Edwin I. Hatch Nuclear Plant
Unit 1 Updated Analysis of Core Shroud Vertical Welds and Supplemental Information

**Responses to NRC Questions Regarding
Hatch Unit 1 Shroud EPFM Analysis**

Responses to
Request for Additional Information
The Updated Analysis of Core Shroud Vertical Welds
Edwin I. Hatch, Unit 1
Southern Nuclear Operating Company
TAC No. MC 1322

Figure 1 Part-Through Circumferential Crack in Cylinder Under Remote Tension

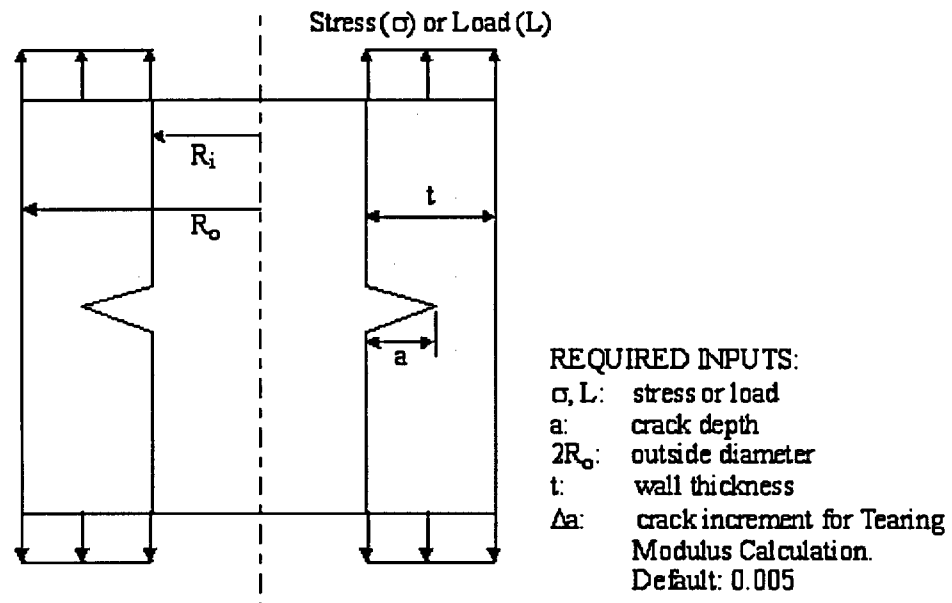
2.2 On Page 3-1 of Report SIR-03-115, it is stated that $J_{\text{applied}}-T_{\text{applied}}$ curves are based on J-Integral by incrementing the crack size. It is further stated on Page 4-1 of this report that the J-integral is calculated from the crack tip opening displacement (CTOD), as reported in EPRI Report NP-1735, "Methodology for Plastic Fracture." To validate this CTOD approach, provide a comparison of the J-integral determined from a numerical integration over a path encircling the crack tip and those from the CTOD approach.

Two problems were used in the verification. The first problem is a part through circumferential crack in a cylinder under remote tension, Figure 1. The cylinder has a thickness of 9 inches with $t/R = 0.1$. Two different crack sizes and loading conditions were considered. The first case is with a crack depth ratio, a/t , of 0.25 and a remote tension stress at 40 ksi. Both plane strain and plane stress conditions were considered. The second case is a through wall circumferential crack in cylinder under remote tension, Figure 2. The cylinder has a wall thickness of 0.4 inches, with an outside diameter of 2.4 inches. The through crack length ratio, a/b (crack length to circumference), is 0.125, with a remote tension load of 200 kips.
